Serial No.	21-064
NRA/SS	R0
Docket No.	50-336
License No.	DPR-65

**DOMINION ENERGY NUCLEAR CONNECTICUT, INC.**  
**MILLSTONE POWER STATION UNIT 2**  
**RESPONSE TO REQUEST FOR ADDITIONAL INFORMATION FOR ALTERNATIVE**  
**REQUEST RR-05-06 - INSPECTION INTERVAL EXTENSION FOR STEAM**  
**GENERATOR PRESSURE-RETAINING WELDS AND FULL-PENETRATION**  
**WELDED NOZZLES**

**RESPONSE TO REQUEST FOR ADDITIONAL INFORMATION FOR**

**INSPECTION INTERVAL EXTENSION FOR STEAM GENERATOR PRESSURE-RETAINING  
WELDS AND FULL PENETRATION WELDED NOZZLES**

**Figure RAI-3-1**  
**Through-Wall Stress Distributions at Path P4 for the PWR SG: (a) Pressure Plus Thermal Stresses (same as Figure 7-25 in EPRI Report 3002015906) and (b) Pressure Stresses**

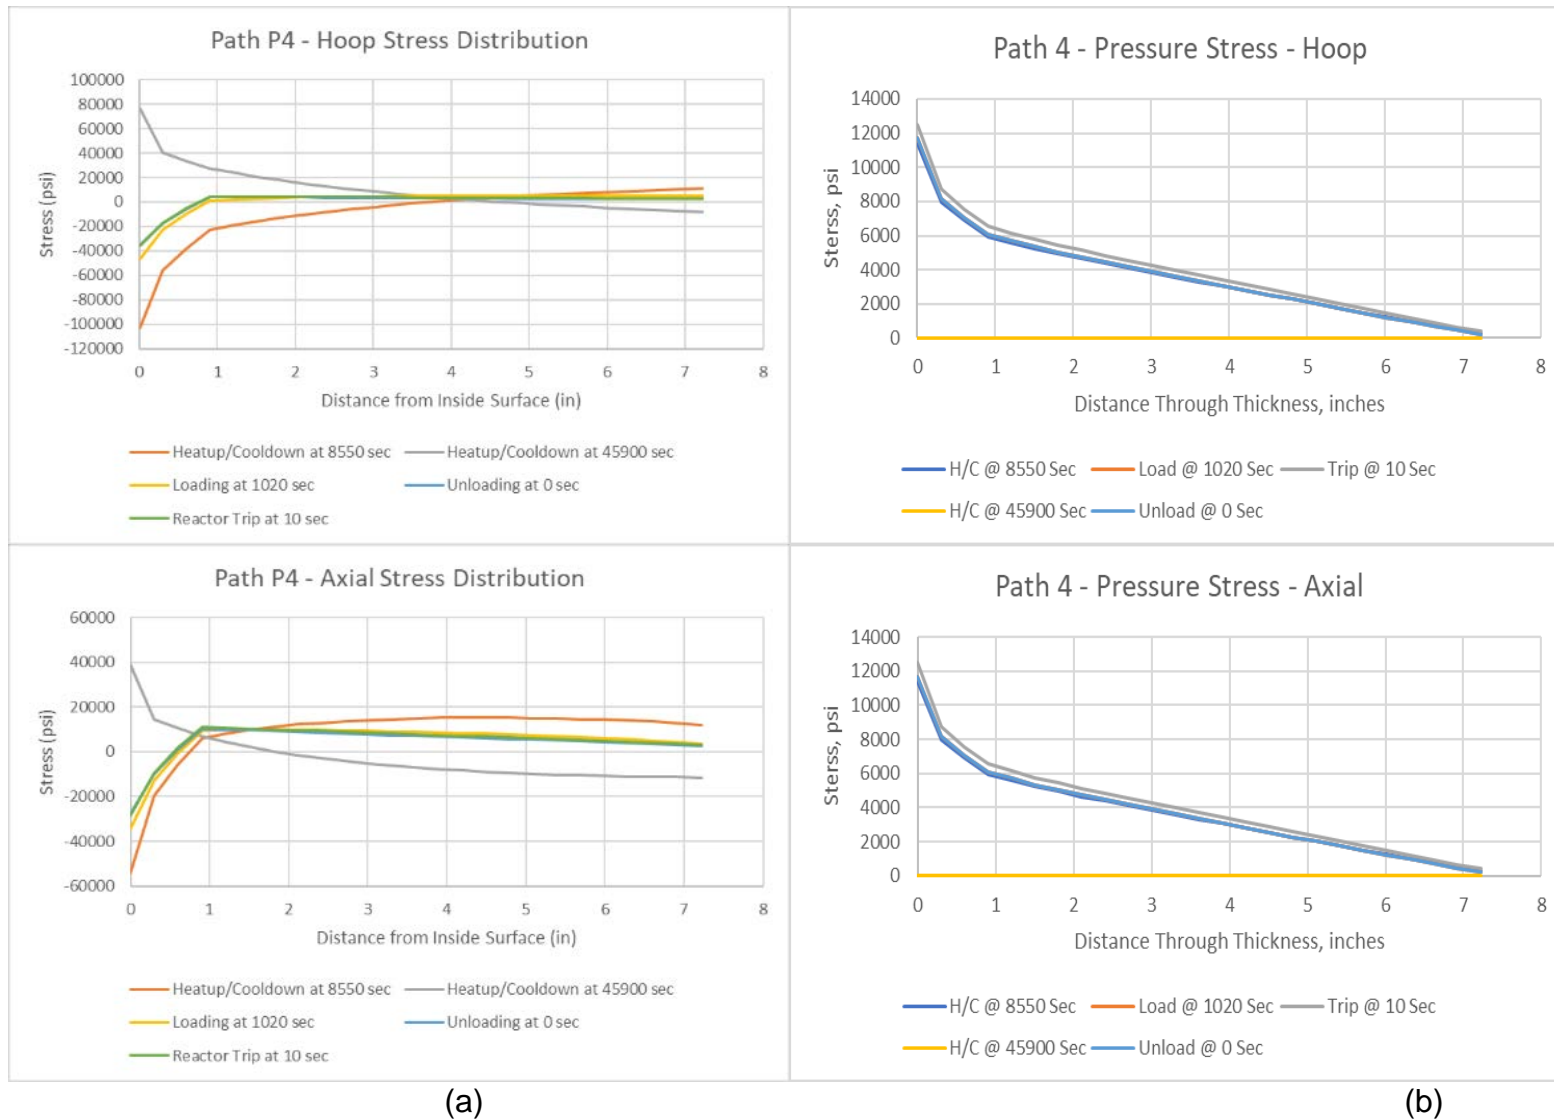
- (a) The through-wall stress distribution plots in Figures 7-25 through 7-28 of EPRI report 3002015906 for the B2.31, B2.40, C1.10, C1.20, and C1.30 welds do not show the stress distributions for the unit pressure case. Thus, the NRC staff cannot verify if the pressure stress dominates in these welds. Sections 4.3.3 and 4.6 of EPRI report 3002015906 state the dominance of the radius-to-thickness (R/t) ratio, which reflect the dominance of the pressure stress.*

*Show that the pressure stress dominates the thermal transient stresses for the B2.31, B2.40, C1.10, C1.20, and C1.30 welds requested in the submittal for MPS2.*

In Figures 7-25 through 7-28 in EPRI Report 3002015906 for ASME Section XI Items Nos. B2.31, B2.40, C1.10, C1.20, and C1.30, the thermal transients were all run with actual pressure loading included using the SG primary and secondary side pressures (which are different) during each transient. Extracting the effects of the pressure stresses alone were not possible from those runs. Therefore, the pressure stresses were not displayed separately for the SG welds as they were for the primary side inlet nozzles in Figures 7-17 and 7-18 in EPRI Report 3002015906. The primary side inlet nozzles are subjected only to primary side pressure so a unit pressure run was made independently of the thermal transient loadings.

To determine the effect of pressure stress alone, the analysis was reperformed with only the actual SG primary and secondary side pressures (not a unit pressure) applied for the associated thermal transients (thermal stresses not included). Figures 7-25 through 7-28 in EPRI Report 3002015906 are reproduced on the left side (a) of Figures RAI-3-1 through RAI-3-4. The pressure only stress distributions for the various transients are plotted separately on the right side (b) of each figure. Comparing the plots on the left side (a) of each figure (pressure plus thermal stresses) to the plots on the right side (b) of each figure (pressure stresses) indicates that the pressure stresses are dominant for all cases except for Path P4, which is the primary side bottom head weld. The stress distributions for Path P4 are significantly influenced by the different thermal coefficients of expansion for the stainless steel cladding and the low alloy steel base material using an assumed stress-free temperature of 70°F. However, starting at approximately two inches through the thickness from the inside surface, the thermal stresses caused by the differential thermal expansion of the two materials diminish, and the pressure stresses dominate. Therefore, for Path P4, pressure stresses dominate the total stress for the larger crack depths that contribute to the probabilities of leakage and rupture.

**Figure RAI-3-5**  
**Time History Stresses (Pressure Plus Thermal) at the Inside Surface for Path P1(N) for the CE Design PWR SG Inlet Nozzle (compares to Figure 7-17 in EPRI Report 3002015906)**

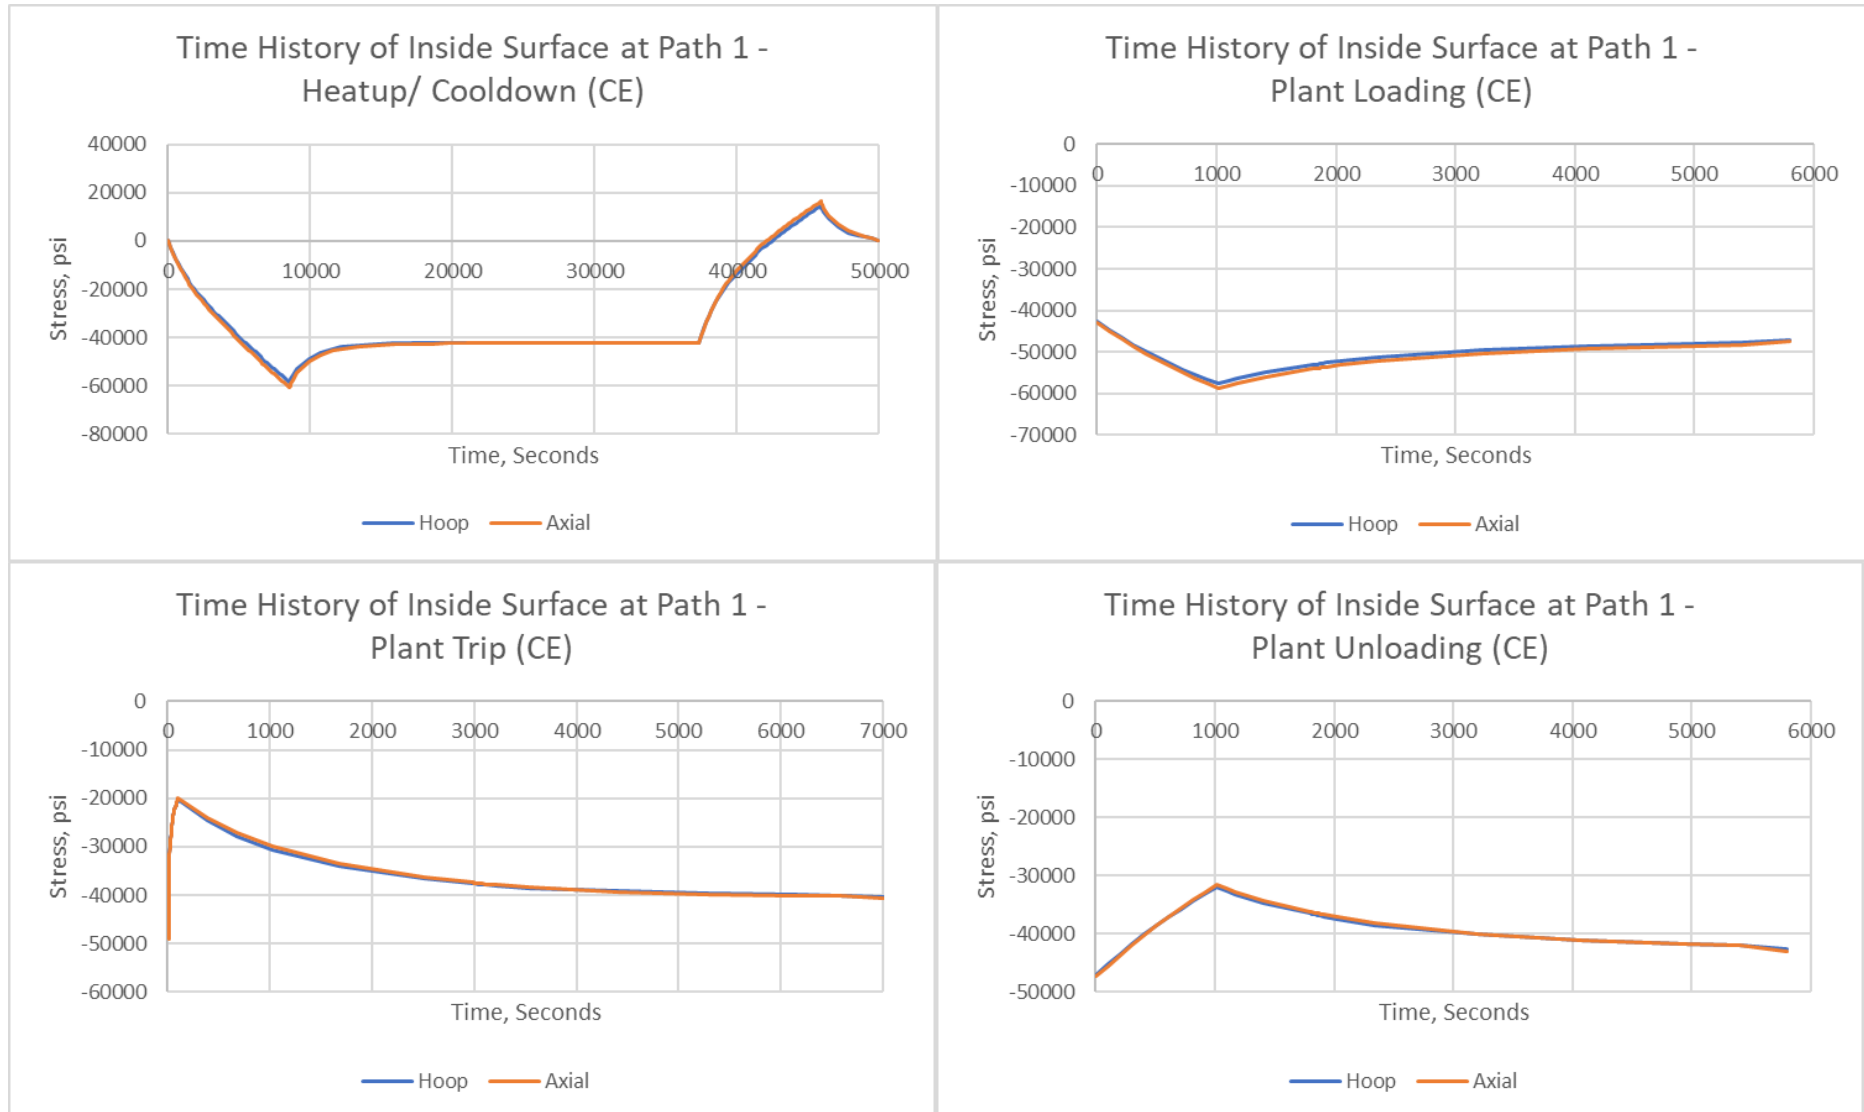
- (b) The through-wall stress distribution plots for the thermal transients in Figures 7-17 and 7-18 of EPRI report 3002015906 for the B3.130 welds show compressive stresses at the inner surface (except the Heatup/Cooldown transient). Tensile stresses at the inside surface are typically expected for transients that have temperature drops, such as Reactor Trip which has a temperature drop of 75°F in 10 seconds as described in Section 5.2.2 of EPRI report 3002015906.*

The entire stress time histories on inside surfaces of the PWR SG inlet nozzle for the four transients reported in Figures 7-17 and 7-18 in EPRI Report 3002015906 for Path P1(N) (CE design) and Path P2N (B&W design) are shown in Figures RAI-3-5 and RAI-3-6, respectively.

The transients with temperature drops (i.e., the Reactor (or Plant) Trip and Plant Unloading transients) start with the SG hot and therefore, the inside surfaces at the start of these transients are in significant compression due to the differential thermal expansion between the stainless steel cladding and the low alloy steel base material using an assumed, stress-free temperature of 70°F. As shown in the two figures, the stresses on the inside surface at the onset of these two transients become less compressive. However, the temperature drop is not high enough during these transients for the stresses to become tensile. On the other hand, the cooldown portion of the Heatup/Cooldown transient generates through-thickness temperature variations that overcome the compressive stresses caused by the differential thermal expansion of the cladding and base material. This effect is large enough to produce tensile stresses, as indicated at a time of approximately 45,000 seconds, for the Heatup/Cooldown transient in Figures RAI-3-5 and RAI-3-6.

**Figure RAI-4-1: Applied K vs. Fracture Toughness as a Function of Temperature  
for Case ID SGPNV-P1A-(N)  
(Using Plant-Specific Maximum SG Material  $RT_{NDT}$  Value of 0°F)**

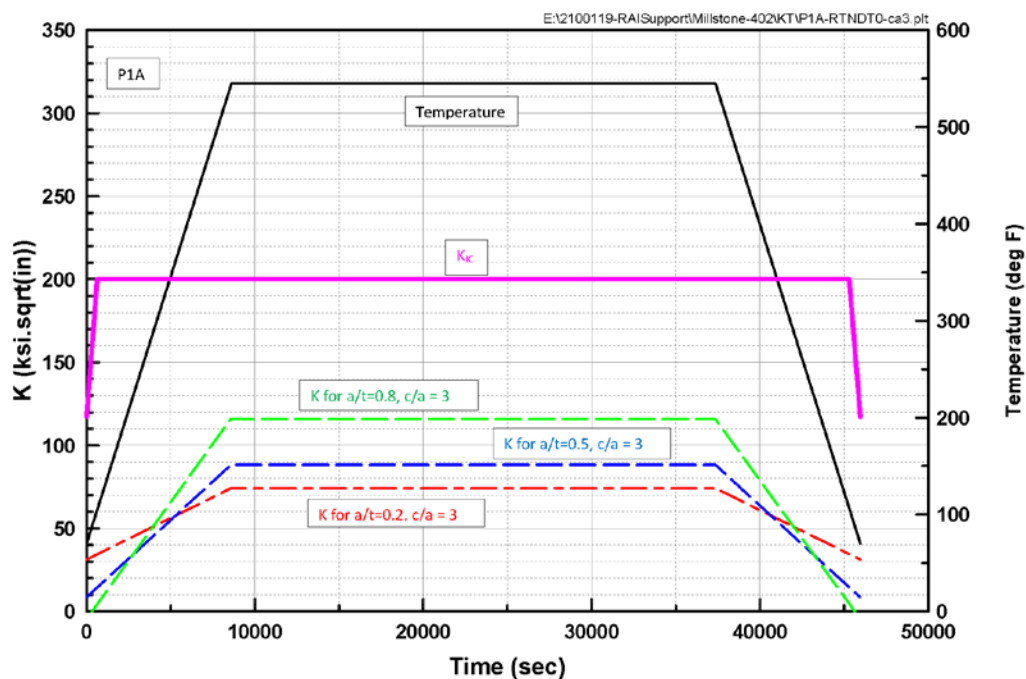
*For the B2.31, B2.40, and B3.130 welds of MPS2 requested in the submittal, Table A2 in Attachment 2 of the submittal shows the minimum and maximum temperatures (70°F and 535°F, respectively) for the Heatup/Cooldown transient. Section 8.2.2.5 of EPRI report 3002015906 states that the minimum temperature (200°F) during this transient corresponds to Figure 7-22 of EPRI report 3002015906, and therefore, a fracture toughness (KIC) set at the upper shelf value of the ASME Code KIC curve, 200 ksi√in, may be used. The NRC staff noted that Figure 7-22 of EPRI report 3002015906 is at the end of heatup (as noted in the figure). During the ramp periods in the beginning and ending of the Heatup/Cooldown transient, the temperatures at the subject locations of the B2.31, B2.40, and B3.130 welds of MPS2 could be lower than 200°F and thus, KIC could be lower than 200 ksi√in. For instance, during the audit summary report for PROMISE Version 1.0 (ADAMS Accession No. ML20258A002, Item No. 2.e.iii), the NRC staff observed that for the SG feedwater nozzle, KIC could be as low as 130 ksi√in during the Heatup/Cooldown transient and that this lower value of KIC is addressed by the sensitivity study results on fracture toughness in Tables 8-13 and 8-14 of EPRI report 3002014590. The NRC staff noted that the lowest KIC value, 80 ksi√in, used in the sensitivity study on fracture toughness in EPRI report 3002015906 is the same as the lowest KIC value used in the sensitivity study on fracture toughness in EPRI report 3002014590. However, the NRC staff noted that the pressure for the B2.31, B2.40, and B3.130 welds of MPS2 is more than twice the pressure analyzed for SG feedwater nozzle in the audit report since these welds are on the primary side of the reactor coolant system. The NRC staff also noted that the probability of rupture value of 1.50E-07 per year for the limiting case (SGPTH-P4A for a KIC value of 80 ksi√in) in Table 8-14 of EPRI report 3002015906 is higher than the probability of rupture value for the limiting case value of 3.75E-08 per year for the SG feedwater nozzle for a KIC value of 80 ksi√in. The NRC staff further noted in Attachment 3 to the submittal that the B2.31 welds requested for MPS2 had an examination coverage as low as 49.58%. With this examination coverage, the probability of rupture of value for the limiting case in Table 8-14 of EPRI report 3002015906 could exceed the criterion of 1E-06 per year since 1.50E-07 per year is only about one order magnitude lower than the criterion.*

From the DFM results in Table 8-3 of EPRI Report 3002015906, the critical Case ID for Item No. B3.130 (for the CE SG design) is SGPNV-P1A-(N), and for Item Nos. B2.31 and B2.40 is SGPTH-P4A. These Case IDs also show the most sensitivity to fracture toughness in the PFM evaluation as presented in Tables 8-13 and 8-14 of EPRI Report 3002015906. The DFM results for Case ID SGPTH-P4A are bounding compared to the limiting Case ID SGPSCH-P15A for the MPS2 SG design. Specifically, the DFM result for Case ID SGPTH-P4A is 641 years from Table 8-3 of EPRI Report 3002015906, whereas the DFM result for Case ID SGPSCH-P15A is 694 years as identified in Table RAI-2-1 in the response to RAI-2. Therefore, Case IDs SGPNV-P1A-(N) and SGPTH-P4A were selected for an additional evaluation to respond to this RAI request.

The stress intensity factor ( $K$ ) and temperature history at the inside surface for Case IDs SGPNV-P1A-(N) and SGPTH-P4A for Heatup/Cooldown transient (including RCS pressure) are provided in Figures RAI-4-1 and RAI-4-2 for three flaw depths that span the range of depths covered in the evaluation from EPRI Report 3002015906 ( $a/t = 0.2, 0.5$  and  $0.8$ ). Based on a review of the supporting calculations, the maximum aspect ratio (crack half-length over depth, or  $c/a$ ) from the DFM evaluation performed in Section 8.2 of EPRI Report 3002015906 for these two Case IDs is approximately 1 to 2. A conservative (longer flaw) aspect ratio of 3 was selected for use in this evaluation.

The stress intensity factor time histories were calculated for the three flaw depths for the Heatup/Cooldown transient, and the fracture toughness history for the transient was calculated using the equation for  $K_{IC}$  in Paragraph A-4200 of Nonmandatory Appendix A of ASME Code, Section XI. An upper bound value of  $RT_{NDT}$  of  $0^{\circ}\text{F}$  was used for the MPS2 SGs, based on a review of all available plant-specific SG materials specifications. As shown in Figures RAI-4-1 and RAI-4-2, the calculated applied MPS2-specific stress intensity factors are bounded with margin by the corresponding  $K_{IC}$  calculated as a function of temperature throughout the transient, for all three flaw depths.

**Figure 6. Path Locations**  
(similar to Figure 7-24 of EPRI Report 3002015906)

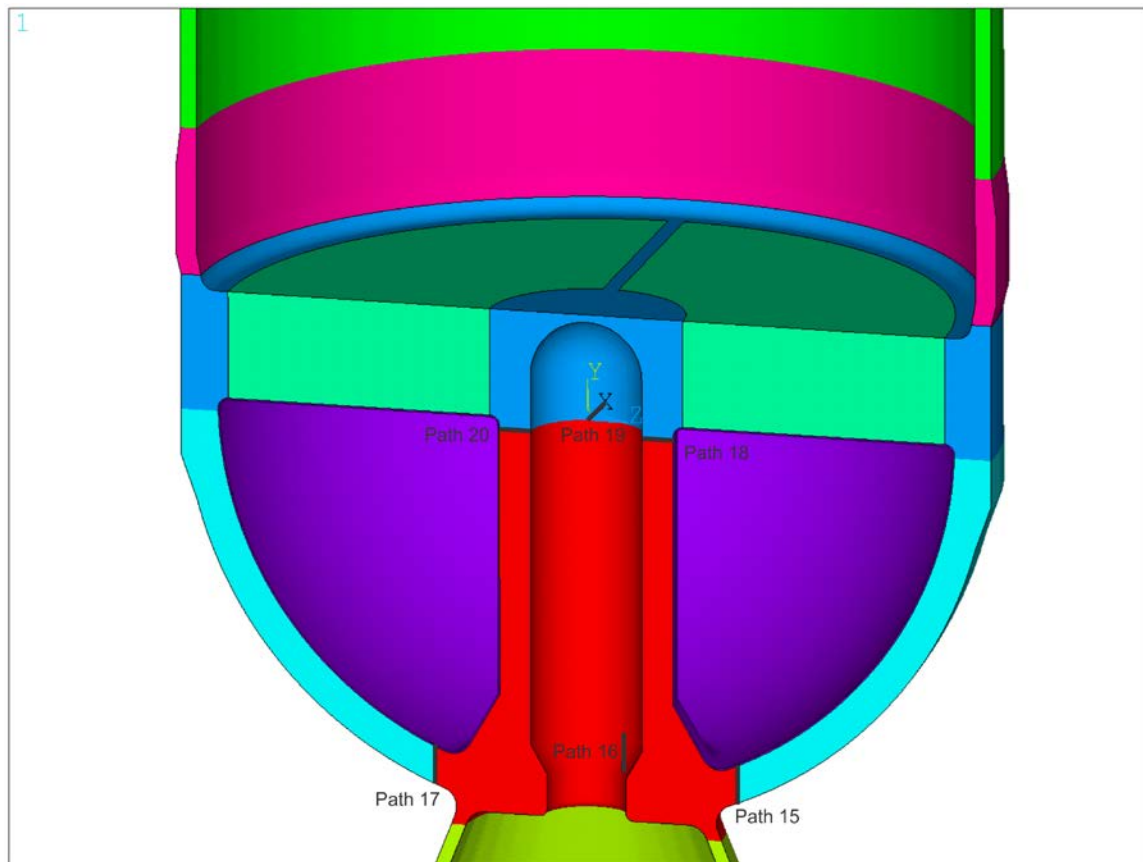
- (a) *Figure A2 in Attachment 2 to the licensee's submittal shows the configuration of the "Stay Tube to Head Weld" and "Stay Tube to Tubesheet Weld." It is not clear to the NRC staff whether "Stay Tube to Head Weld" is the same as the "Stay Cylinder Base to Hemisphere (Head)" (SG-1-BHC-1-A and SG-2-BHC-1-A) and whether "Stay Tube to Tubesheet Weld" is the same as "Stay Cylinder to Tube Sheet" (SG-1-TSS-3-A and SG-2-TSS-3-A). Also, "Stay Tube to Head Weld" and "Stay Tube to Tubesheet Weld" in Figure A2 in Attachment 2 to the licensee's submittal do not seem to be represented by any of the paths in Figure 7-24 of EPRI report 3002015906.*

- (b) *In addition, the NRC staff noted that the configuration of the "Stay Tube to Tubesheet Weld" in Figure A2 appears to include a tube attached to the tubesheet, rather than a plate attached to the tubesheet as shown in Figure 7-24 of EPRI report 3002015906.*

*Discuss which paths in Figure 7-24 of EPRI report 3002015906 represent the "Stay Cylinder Base to Hemisphere (Head)" (SG-1-BHC-1-A and SG-2-BHC-1-A) welds of MPS2 and "Stay Cylinder to Tube Sheet" (SG-1-TSS-3-A and SG-2-TSS-3-A) welds of MPS2, and justify that the stresses in the selected paths are appropriate for these welds.*

with a divider plate that is mechanically restrained without welds. Therefore, a new finite element model representative of the MPS2 configuration was developed and the stress analyses and fracture mechanics analyses in EPRI Report 3002015906 were reperformed with the MPS2 model. Both the deterministic fracture mechanics (DFM) and the probabilistic fracture mechanics (PFM) evaluations were performed. The stress analyses are provided in Attachment 2 of this RAI response letter and the fracture mechanics analyses are provided in Attachment 3 of this RAI response letter.

The stress analyses presented in Attachment 2 of this RAI response letter were performed consistent with the approach used in Section 7.0 of EPRI Report 3002015906. The stress analyses results are provided in Section 6.0 of Attachment 2 of this RAI response letter. The location of the stress paths for the stay cylinder base-to-hemispherical head welds (Paths 15, 16 and 17) and the stay cylinder-to-tubesheet welds (Paths 18, 19 and 20) are provided in Figure 6 of Attachment 2 (which aligns with Figure 7-24 of EPRI Report 3002015906). Typical transient stresses for these stress paths are provided in Figures 7 through 12 of Attachment 2 of this RAI response letter (which align with Figures 7-25 through 7-28 of EPRI Report 3002015906).

Figure 6 of this attachment shows the path locations where stresses were extracted. Paths P15 through P17 were selected for the stay cylinder-to-lower head circumferential
